**DECISION LETTER  
ARCHITECTURAL STANDARDS COMMITTEE**

**DATE: October 26, 2020  
PERMIT: 20-0526-P**

Re: Unit: 01 Lot: 218 - 12420 Bernese Ln

**Decision: Submittal: House 1291SF**

# SITE PLAN

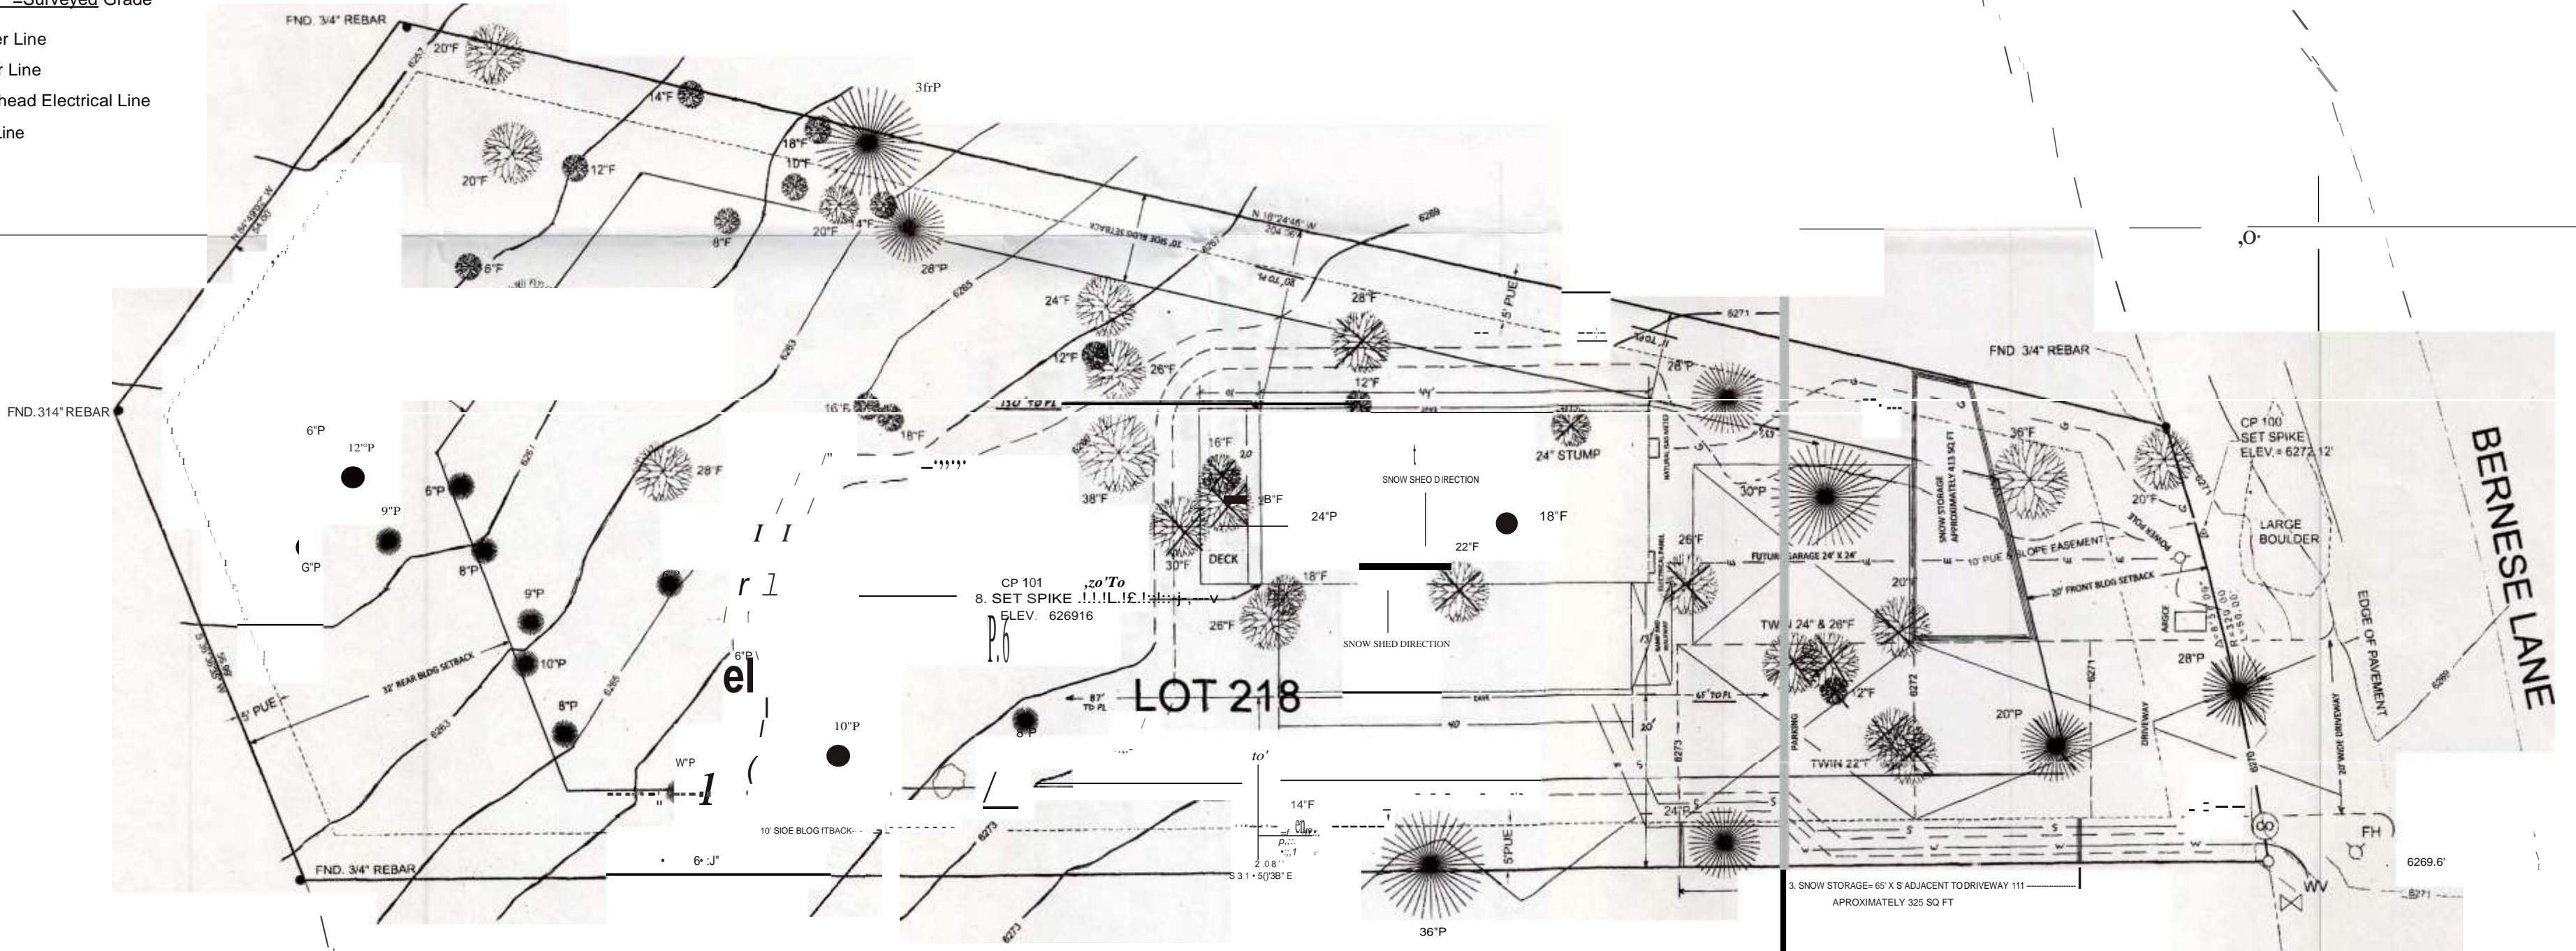
- The committee reviewed the site plan discussed the coverage percentage at 11.8%.
- The committee reviewed the proposed tree removal, the utility lines and noted the power will overhead. The committee discussed the boulder removal at the driveway. The committee commented on the turn-around space in relation to the proposed location of the future garage.

- The committee reviewed the proposed tree removal, the utility lines and noted the power will overhead. The committee discussed the boulder removal at the driveway. The committee commented on the turn-around space in relation to the proposed location of the future garage.

FRONT (STRtf V!E\,/\; Crc E

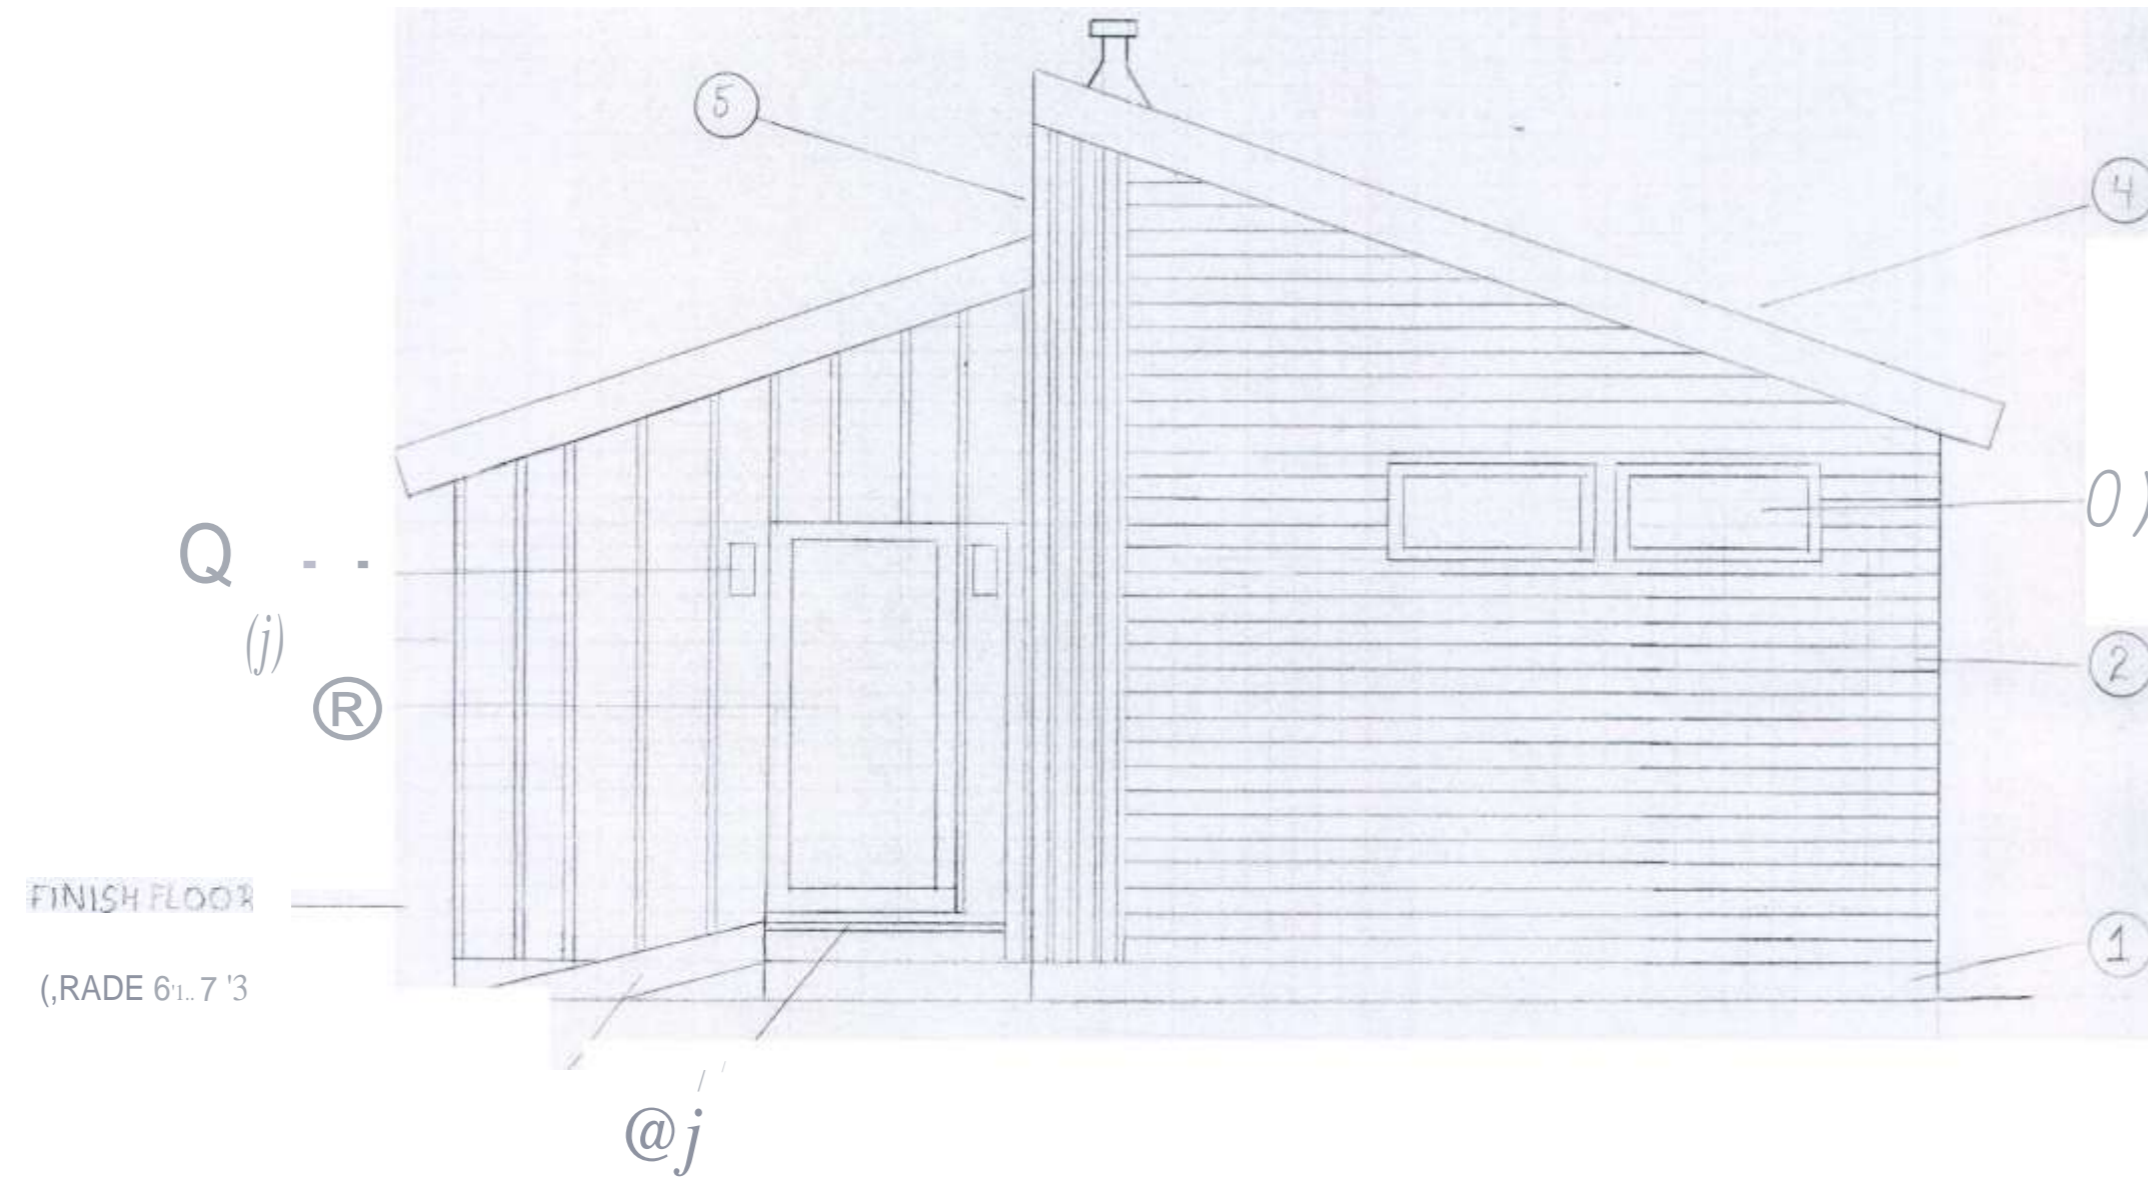
- The committee reviewed the letter from the owner asking for the sheet siding exception on the street view and left side elevation where it is proposed the redwood siding will be stained and sheet siding will be painted.

- The committee discussed window placement on the street view elevation.
- The owner explained the house is 16ft tall and the committee explained a revision is required to dimension the proposed height at the midpoint.

- The committee reviewed the letter from the owner asking for the sheet siding exception on the street view and left side elevation where it is proposed the redwood siding will be stained and sheet siding will be painted.

- The committee discussed the samples given with one being milled redwood with batts and the other plywood with batts. The committee agreed laminating real wood onto plywood is approvable. The owner explained he then will apply real milled wood and not sheet siding on the left and street view elevations.

- The committee discussed window placement on the street view elevation.
  - The owner explained the house is 16ft tall and the committee explained a revision is required to dimension the proposed height at the midpoint.

RIGHT SIDE - ENE

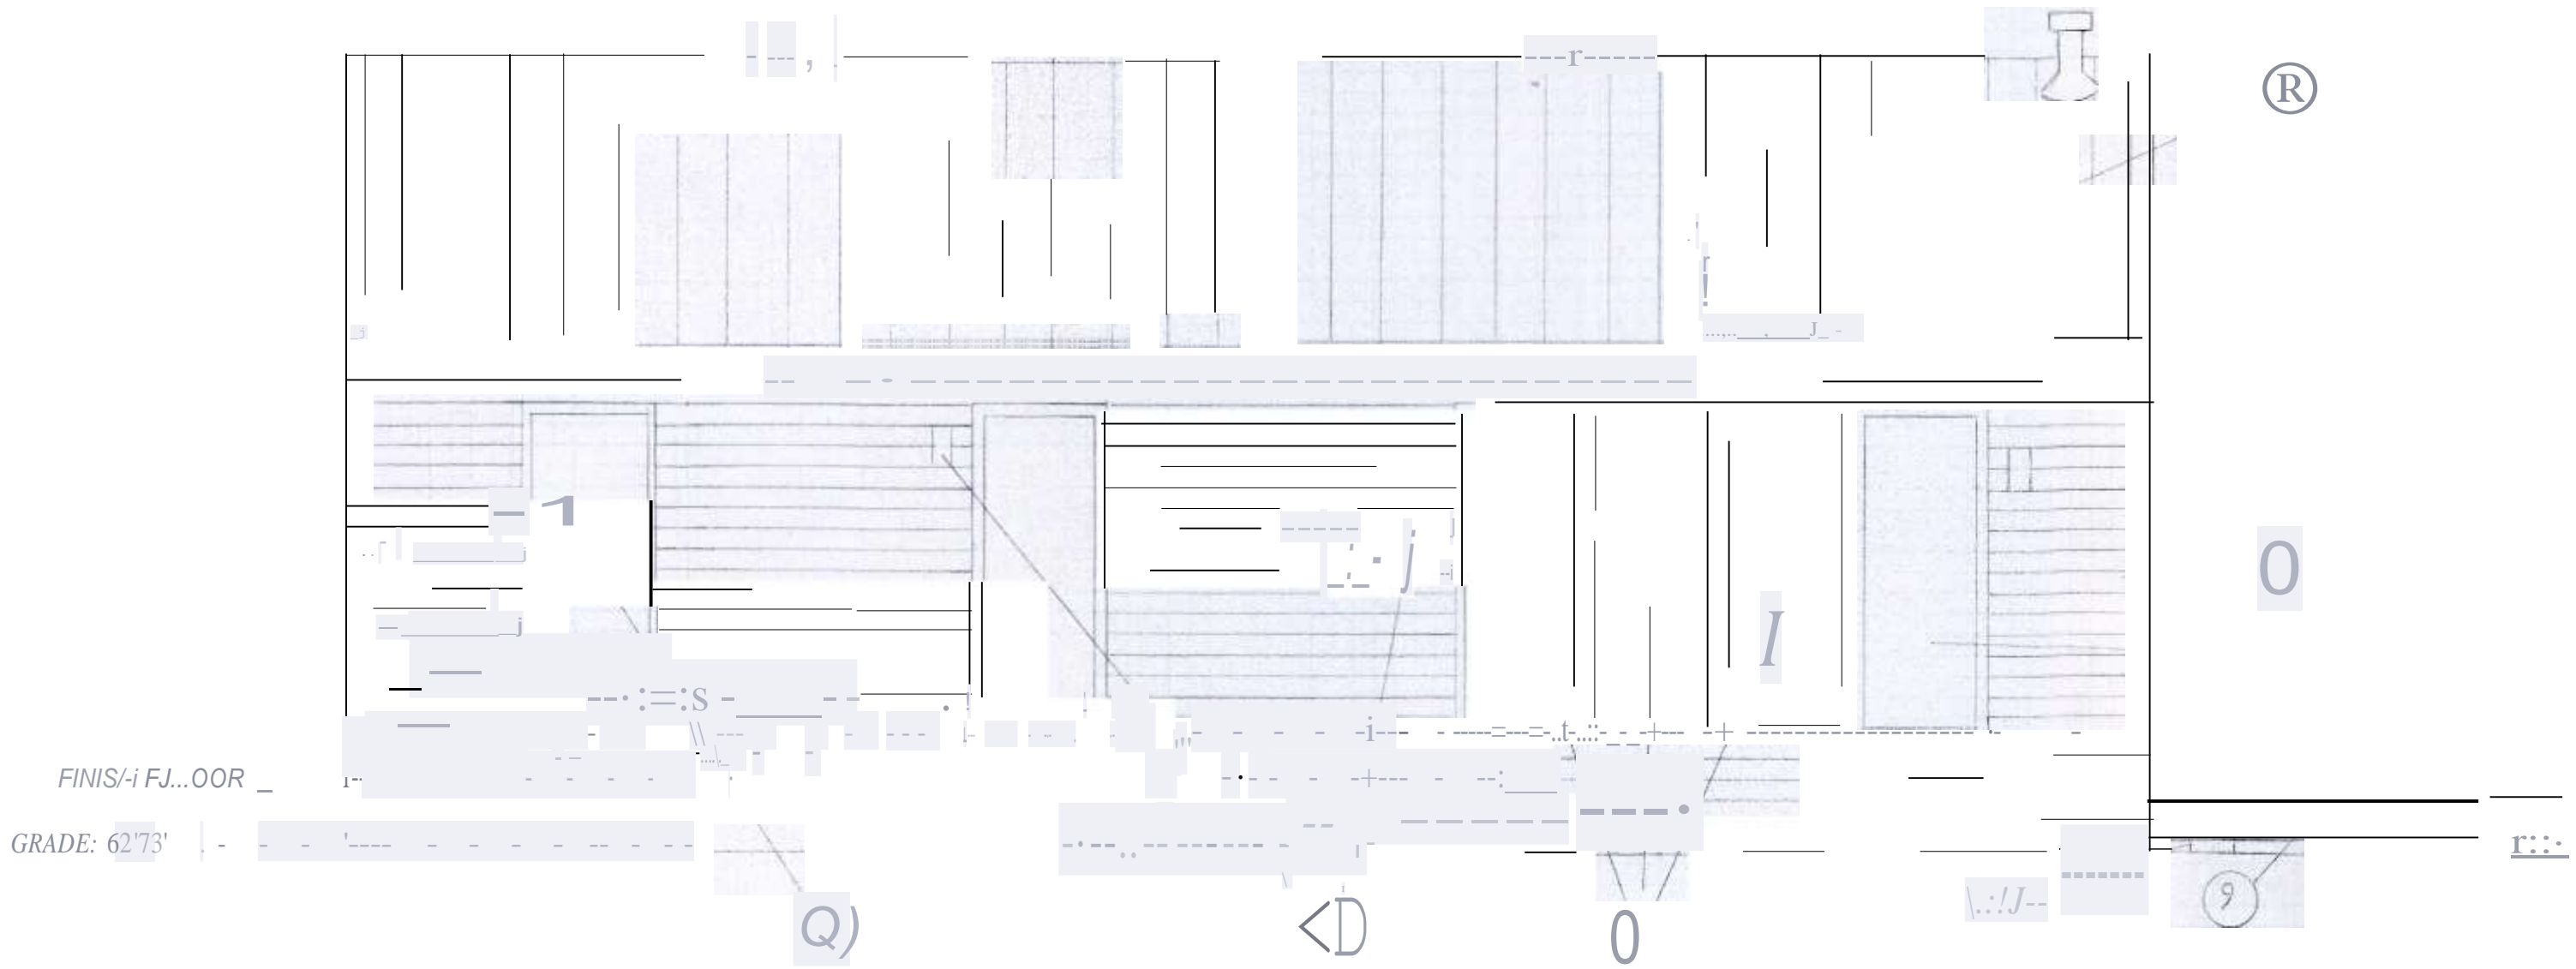
- The committee discussed the 3 lights on the side of the elevation facing the common area. The owner explained more lights on the exterior by the windows gives more privacy within the house.
